FORD AXOD PUMP & VALVE BODY GASKET CHANGES

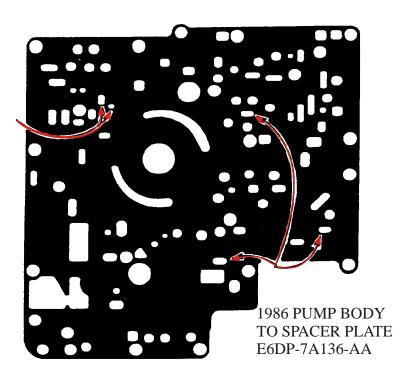
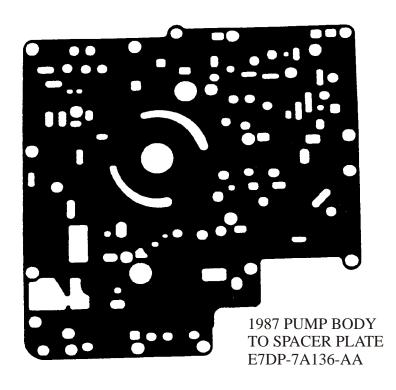
NOTE THE 5 HOLES THAT HAVE BEEN ELIMINATED IN THE 1987 GASKET
